ST. PETER THE APOSTLE
CATHOLIC CHURCH 2ND ADDITION
SEDGWICK COUNTY, KANSAS

RE: SUB 2002-42 -- One-Step Final Plat of St. Peter the Apostle Catholic Church Second Addition.

At the regular meeting of the Subdivision Committee of the Metropolitan Area Planning Commission on Thursday, May 30, 2002, the above captioned plat was considered. The action of the Committee was to approve the one-step final plat, subject to the following:

STAFF REPORT
(ONE-STEP FINAL PLAT APPROVED 5/30/02)

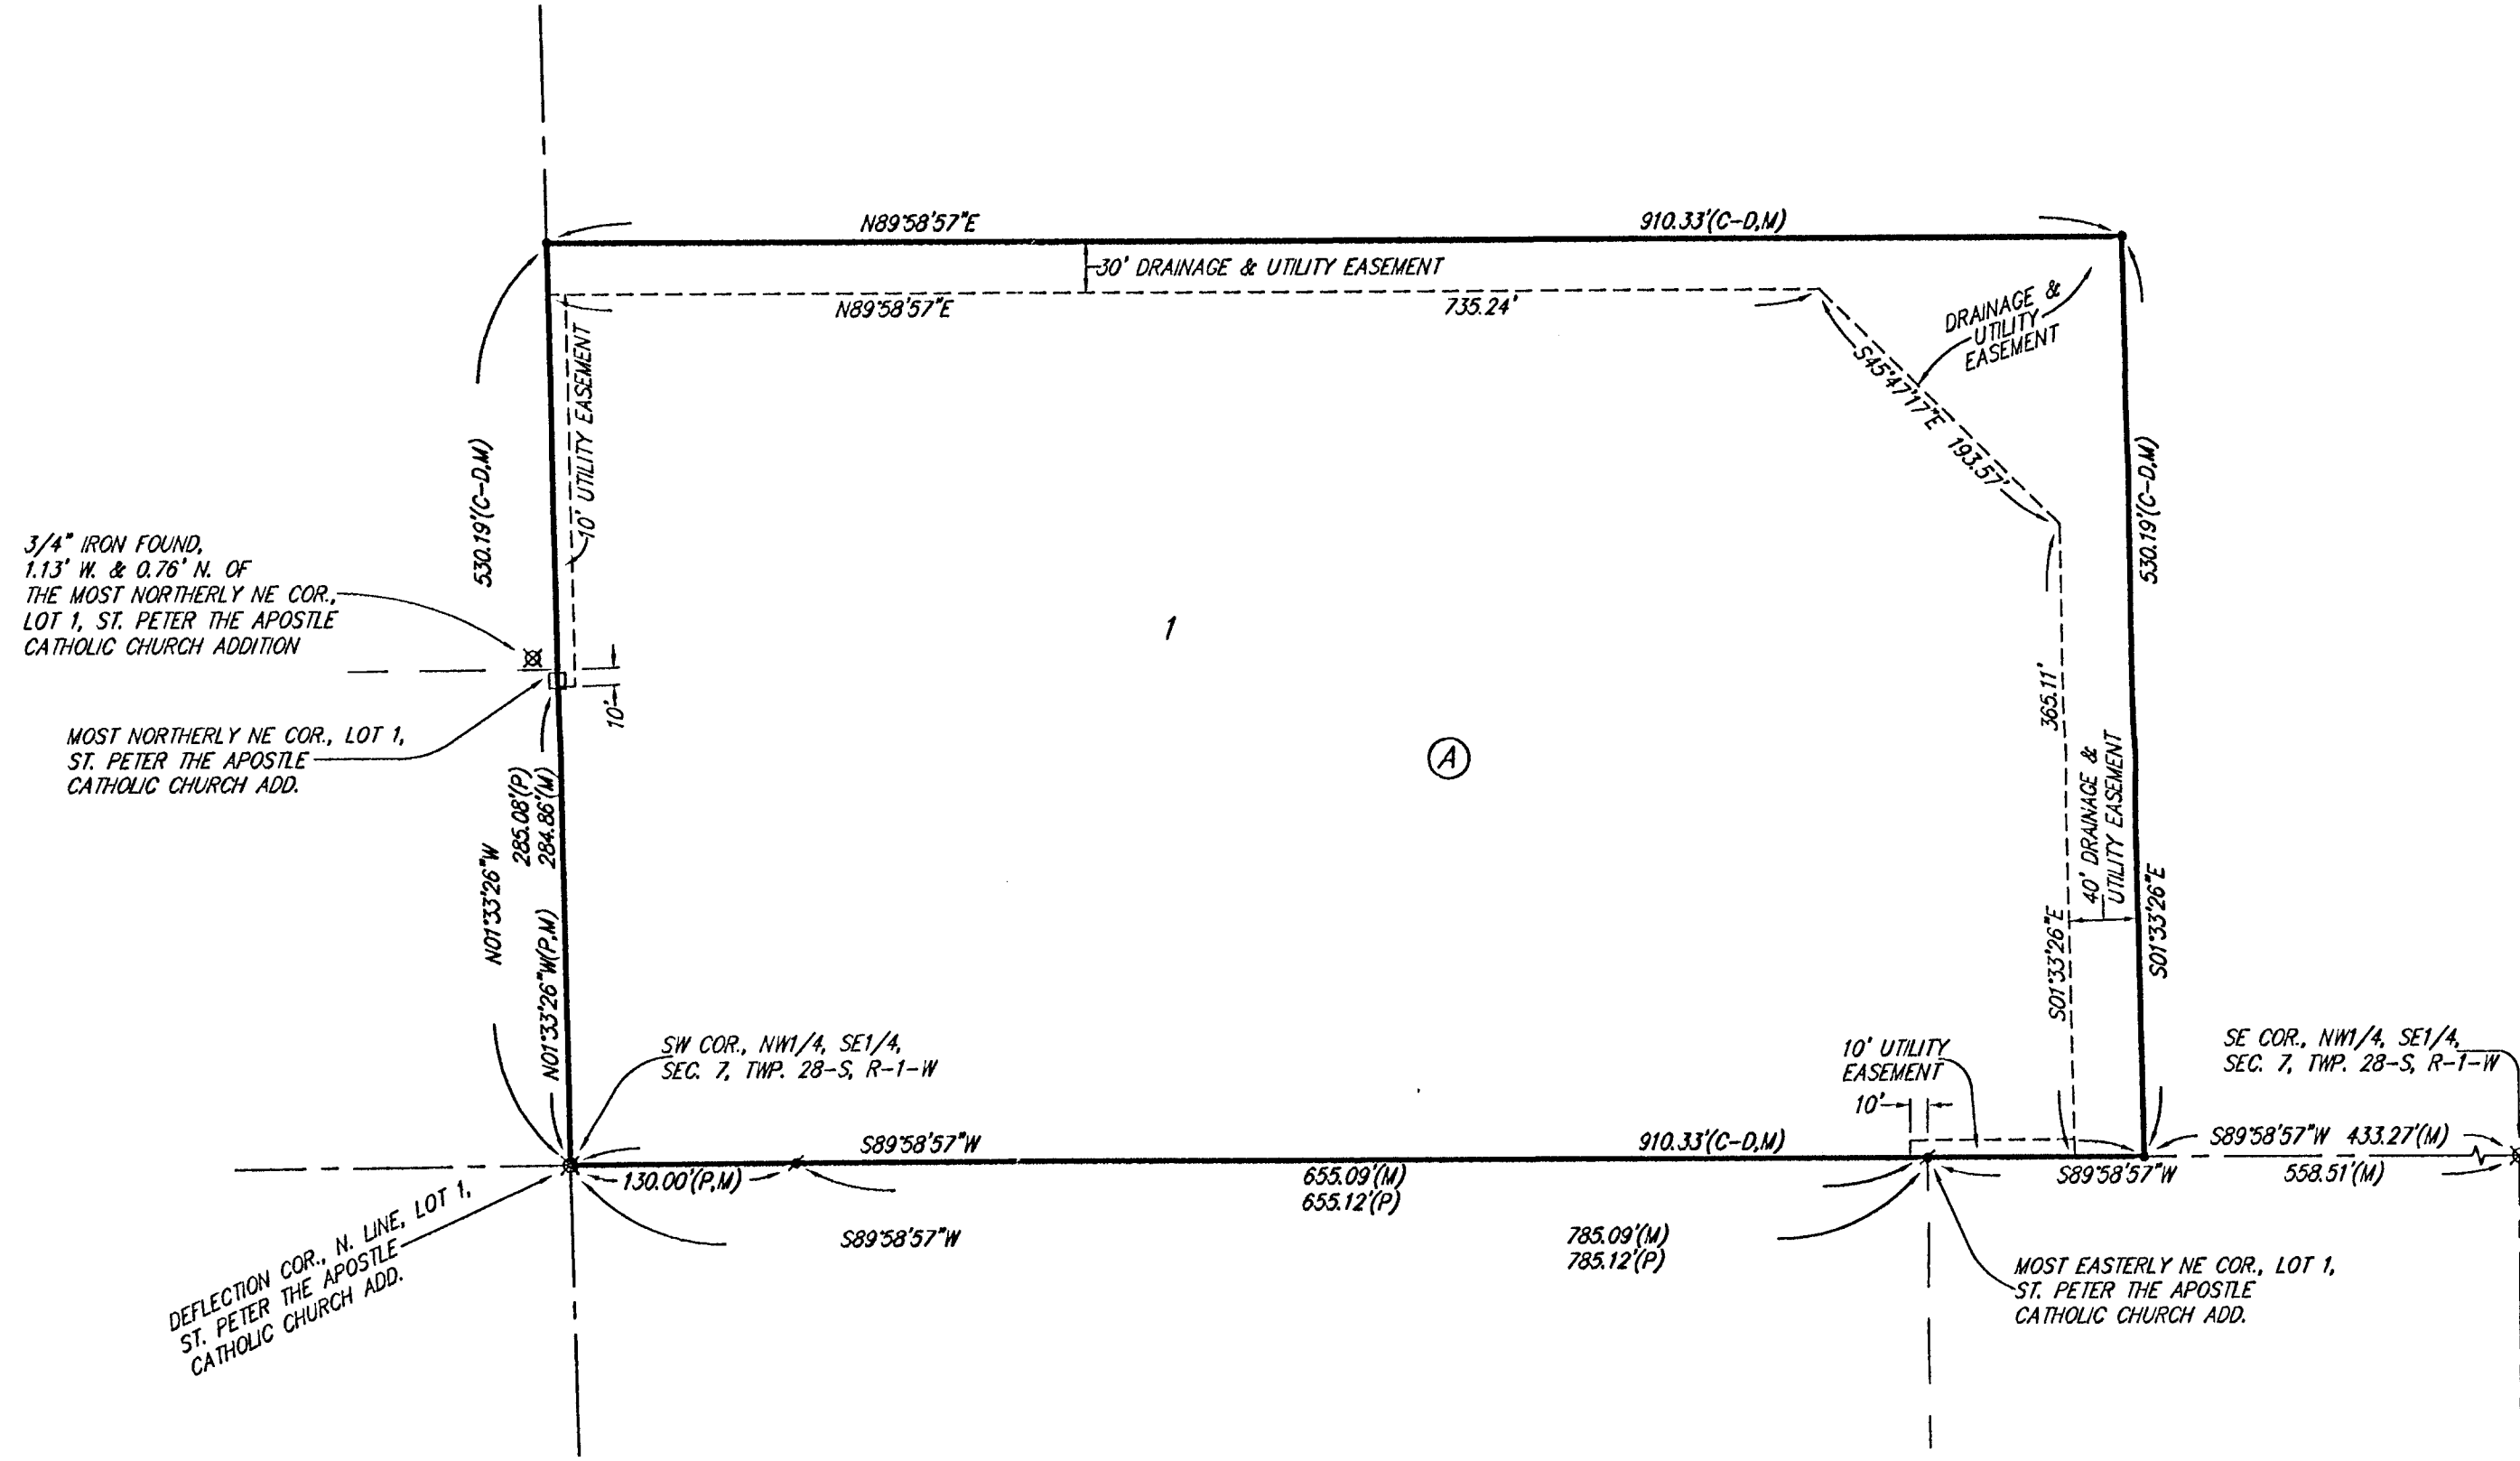
- H. On the final plat, the MAPC signature block needs to reference "J.D. Michaelis, Chair".
- I. On the final plat tracing, the City Council signature block should be revised to replace the Mayor's signature line with the City Manager, preceded above by "At the direction of the City Council".

- J. The platlor's text shall include language that a drainage plan has been developed for the plat and that all drainage easements, rights-of-way, or reserves shall remain at established grades or as modified with the approval of the applicable City or County Engineer, and unobstructed to allow for the conveyance of stormwater.

- A. **City Water and Sewer Department** requests a petition for future extension of sanitary sewer and City water services.
- B. Since neither sanitary sewer nor municipal water is available to serve this property, the applicant shall contact **County Code Enforcement** to find out what tests may be necessary and what standards are to be met for approval of on-site sewerage and water wells. A memorandum shall be obtained specifying approval.

- D. **County Engineering** needs to comment on the status of the applicant's drainage plan. **The drainage plan is approved.**
- E. A cross-lot access agreement shall be provided with the Church property to the south. **County Fire Department has advised that an access easement between St. Peters The Apostle Catholic Church Addition and the proposed second addition has been established based upon a site plan that has been provided to and approved by the County Fire Department. The access easement shall be provided to MAPD.**
